**TOWN OF ERIE
PLANNING COMMISSION MEETING
Wednesday, August 15, 2018**

Resolution P18-09: A Resolution Regarding The Erie Commons PD Amendment No. 8, Adopting Certain Findings Of Fact And Conclusions Favorable To The PD Amendment.

Consideration of a PD Amendment in the Erie Commons Subdivision to amend:

Expired Site Plan

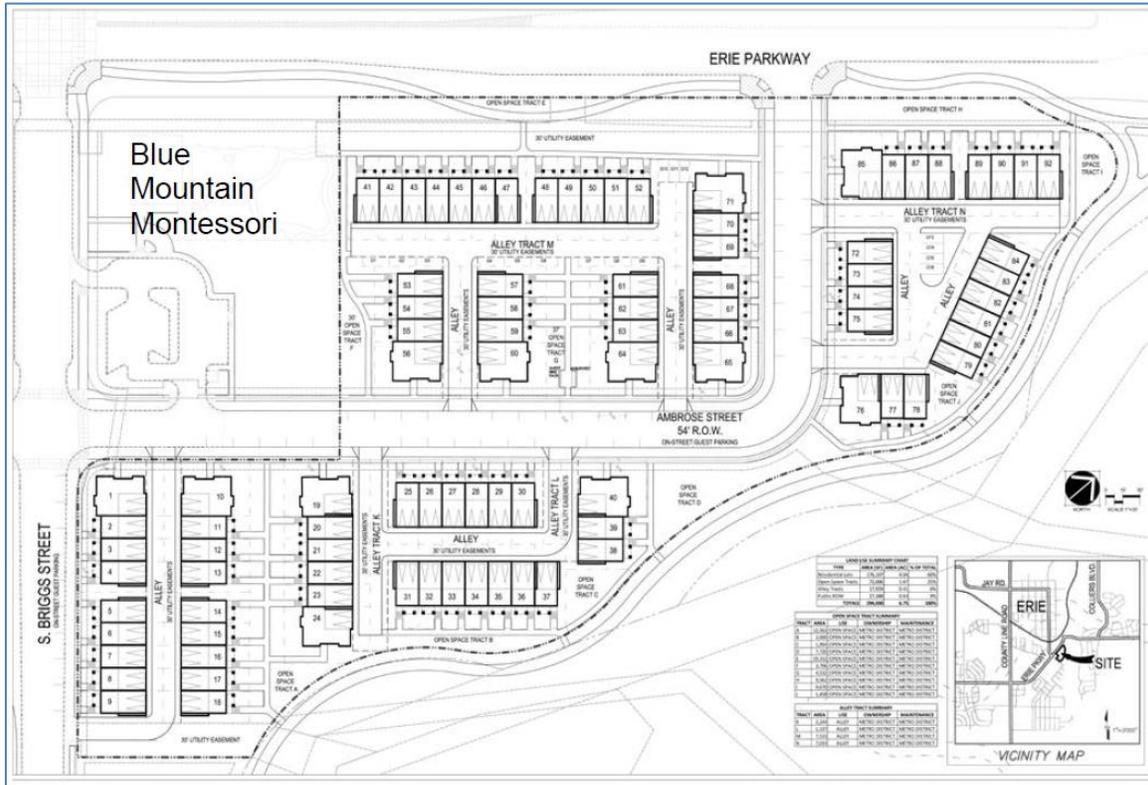
A Site Plan was approved for this project area in 2006 which included 64 tri-plex and townhome units and a pocket park. All units fronted onto a public street or common garden court. The development was never built out leaving the site vacant. The approved site plan has since lapsed and expired. Below is an illustration of the expired plan, provided to show how the dwelling units were oriented on the site.

Proposed Site Plan

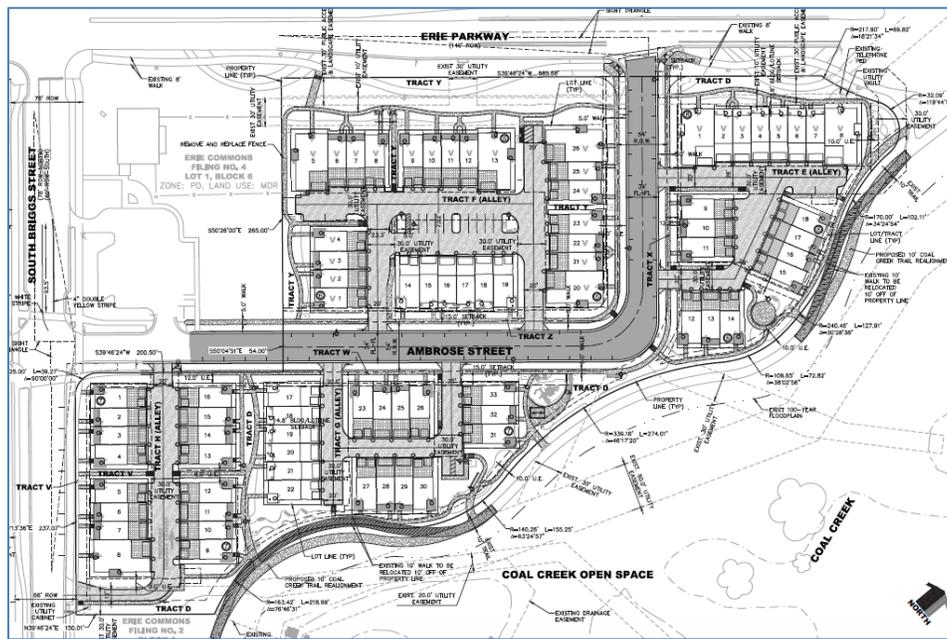
The existing Erie Commons PD Amendment 7 Development Guide does not specifically allow for residential units to be oriented toward off-site natural areas/open space. The applicant is proposing to change this requirement to allow townhome Lots 27-33, Block 7 and Lots 12-18, Block 8 to front onto Coal Creek Open Space. Below is the proposed change; the new language is underlined:

Staff has expressed concern with the orientation of townhomes toward the open space since Sketch Plan. The Sketch Plan appeared before Planning Commission on May 18, 2016 and before the Board of Trustees on June 14, 2016. Staff was concerned with the volume of traffic on the Coal Creek spine trail. This trail serves as a major route in the trail system, carrying the heaviest traffic load with the highest speeds. Staff stated that access onto the spine trail should be limited to specific access points and new setbacks should be in place to minimize conflicts between homeowners and trail users. Staff recommended that the majority of units be side-loaded to the spine trail/open space. This would allow for views into the open space as well as funneling all users to the spine trail on one common walk system. The Open Space and Trails Advisory Board echoed these same concerns.

The applicant and staff have worked to mitigate some of these concerns by limiting the access points to the spine trail by incorporating only five connection points, and 3 rail fencing is proposed along the east property line which will limit traffic conflicts along the Coal Creek spine trail. Also, the PD Amendment incorporates new setback language that includes 15' setbacks to the Exterior Property Boundary, Non-Road Frontage that will create a spatial buffer from the open space that is consistent throughout the development.

The applicant has not provided a majority of side-loaded units as was recommended by staff at Sketch Plan. With the 2016 Sketch Plan, Town Board commented that this layout was acceptable as long as proper distance was maintained from the trail. Staff has worked with the applicant to establish that distance and finds the current proposal acceptable.

1. The primary entrance and façade of individual buildings within a multi-family development shall be oriented towards:
 - a. Primary internal or perimeter streets, or
 - b. Common open space, such as interior courtyards, parks, or on-site and adjacent natural areas, or features with a clearly defined and easily accessible pedestrian circulation system.
